TECHNICAL EVALUATION REPORT  
**RADIOLOGICAL EFFLUENT TECHNICAL  
SPECIFICATION IMPLEMENTATION (A-2)**

BALTIMORE GAS AND ELECTRIC COMPANY  
CALVERT CLIFFS UNITS 1 AND 2

FRC PROJECT C5506

Figure 1. Liquid Radwaste Treatment Systems, Effluent Paths, and Controls, Calvert Cliffs Nuclear Power Plant Units 1 and 2

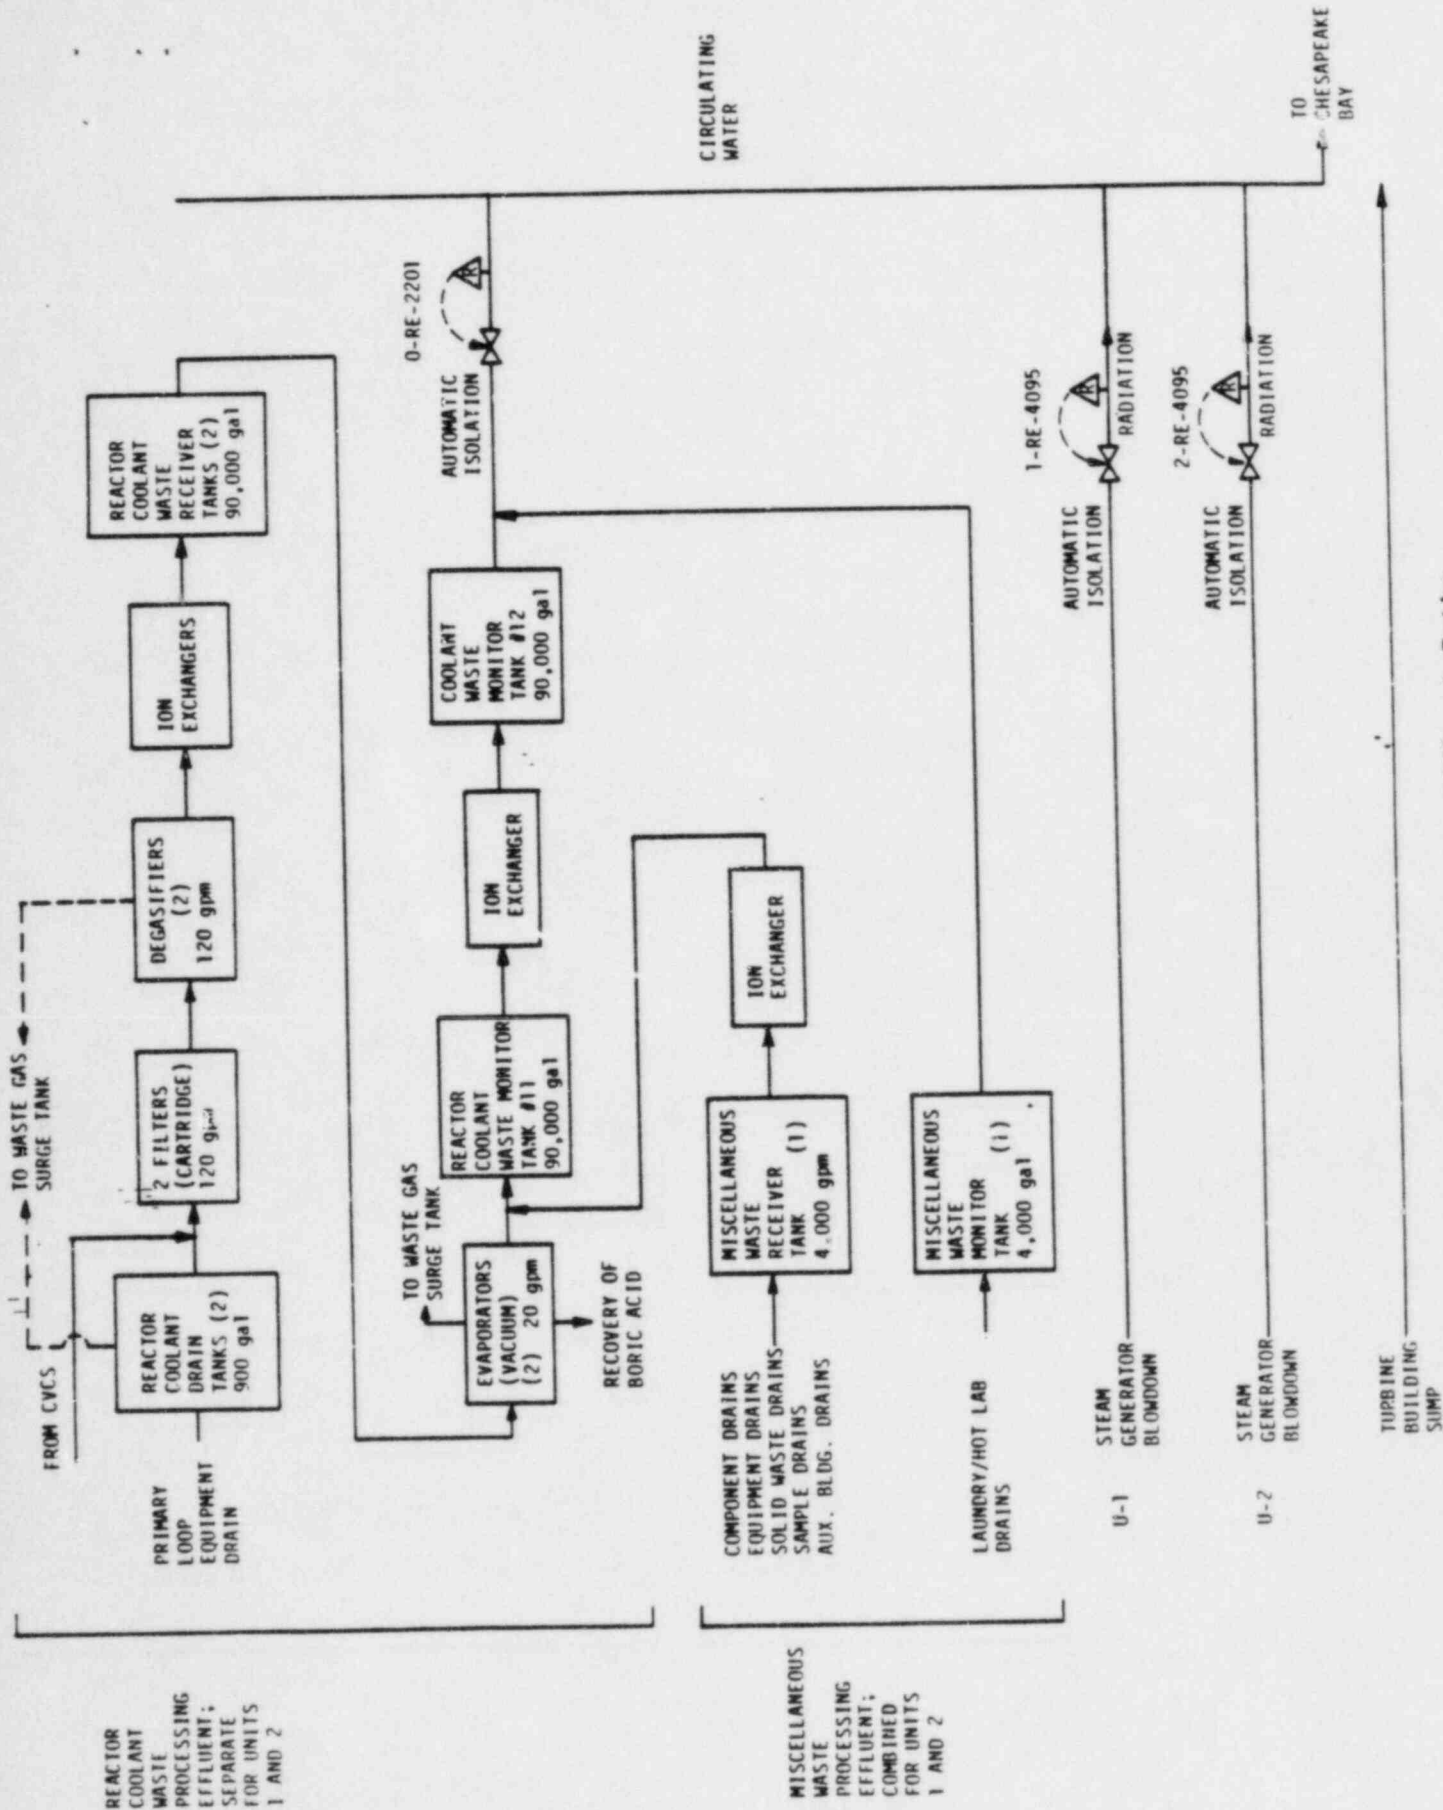
A radiation monitor (0-RE-2201) has been installed for the liquid effluent line (Figure 1) which receives effluent releases from the RCWPS and the MWPS. The monitor also has automatic isolation capabilities. The Licensee also has radiation monitors (1-RE-4095 and 2-RE-4095) for each of the steam generator blowdown for Units 1 and 2, respectively. These radiation monitors also have automatic isolation capability. The turbine building sump is not equipped with a radiation monitor. However, the Licensee has provided a sampling schedule for such effluents (Table 4.11-1 of the submittal), thus meeting the intent of NUREG-0472.

These existing monitoring capabilities provide adequate assurance that the provisions of NUREG-0472 for the radioactive liquid effluent monitoring instrumentation are met.

Figure 2. Gaseous Radwaste Treatment Systems, Effluents Paths, and Controls, Calvert Cliffs Nuclear Power Plant Units 1 and 2

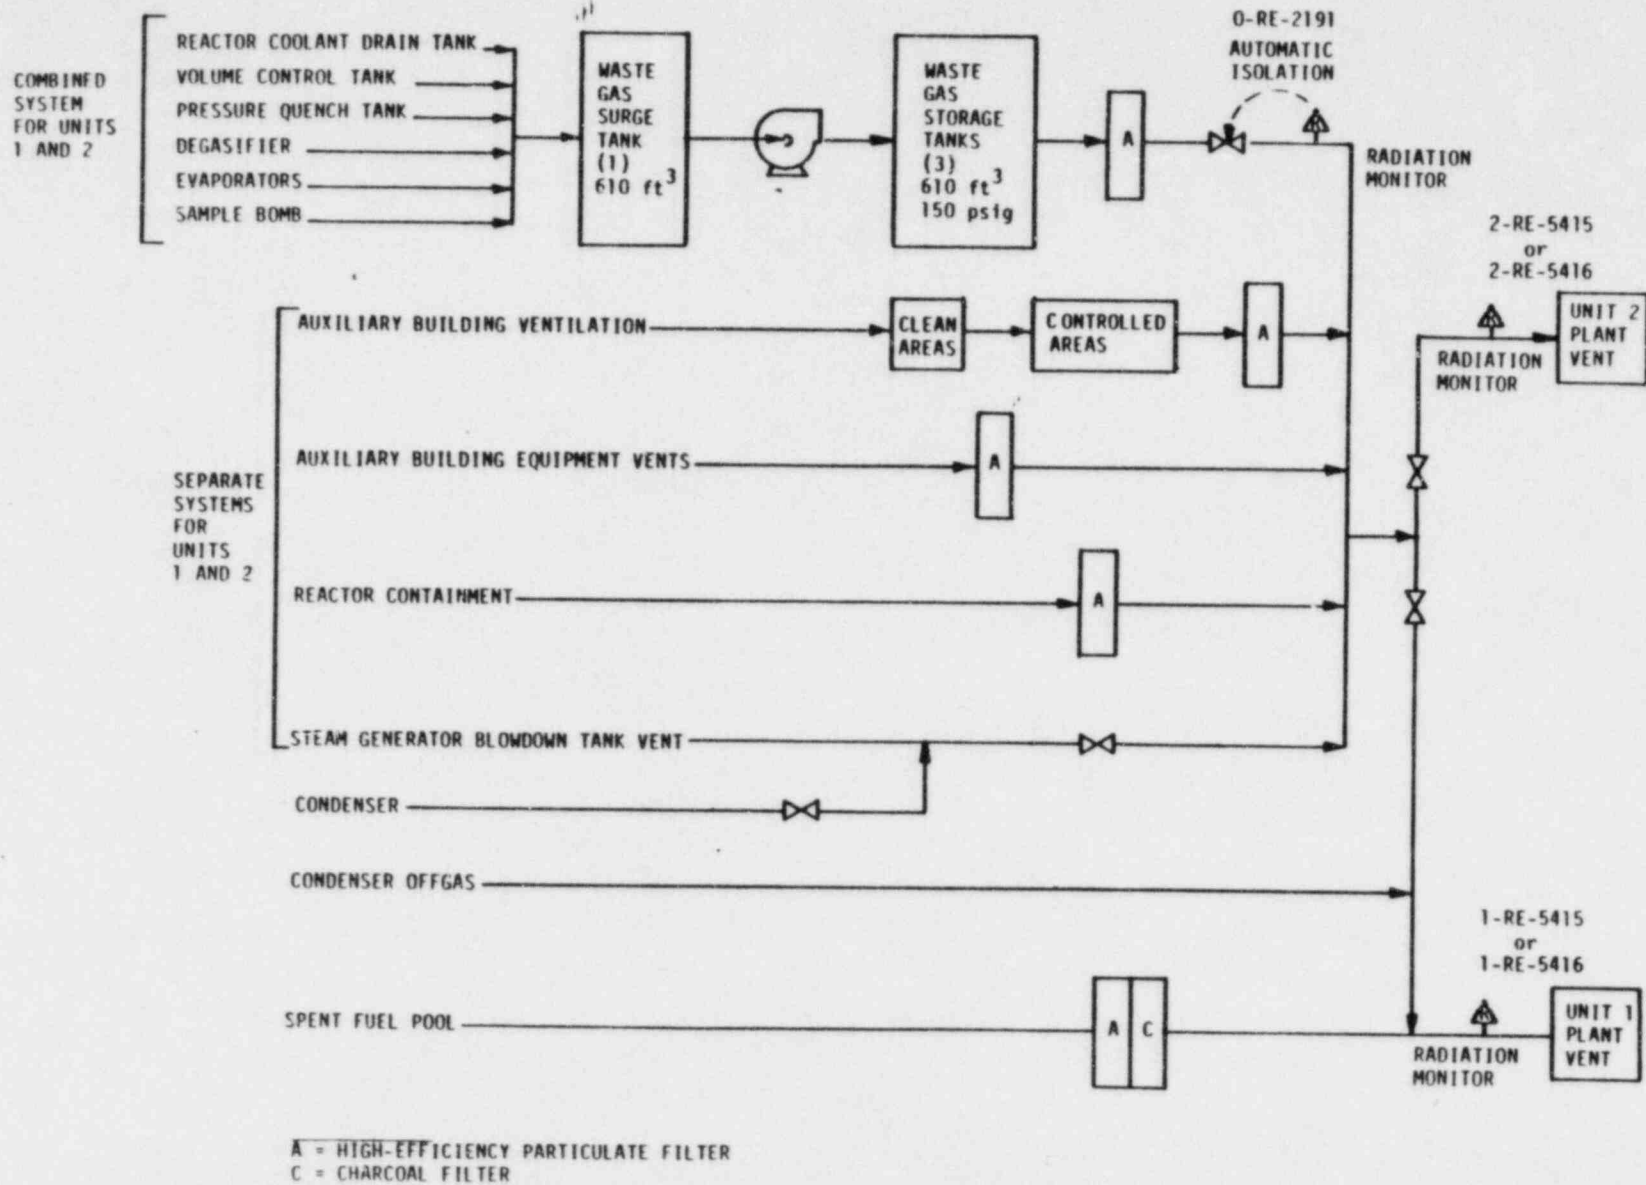
Calvert Cliffs Units 1 and 2 share the same waste gas processing system (WGPS), as shown in Figure 2. The waste gas in the surge tank is discharged to one of the three waste gas decay tanks and, after being sampled, is released through the release header to the plant vents. The units have separate, but identical plant vent systems. Also discharged to the plant vent are the substreams from the auxiliary building ventilation, the auxiliary building equipment vents, the reactor containment, the steam generator blowdown tank vent, the condenser offgas, and the spent fuel pool. Monitors are located at the release header of the WGPS and at each of the plant vents.

Each of the reactor units has a main vent system equipped with a redundant monitoring system (monitors 1-RE-5415/5416 for Unit 1 and 2-RE-5415/5416 for Unit 2) capable of monitoring noble gases, iodines, and particulates.

A noble gas monitor (0-RE-2191) equipped with automatic termination capability is installed at the waste gas holdup system.

These existing gaseous monitoring capabilities provided by the Licensee meet the intent of NUREG-0472 for radioactive gaseous effluent monitoring instrumentation.
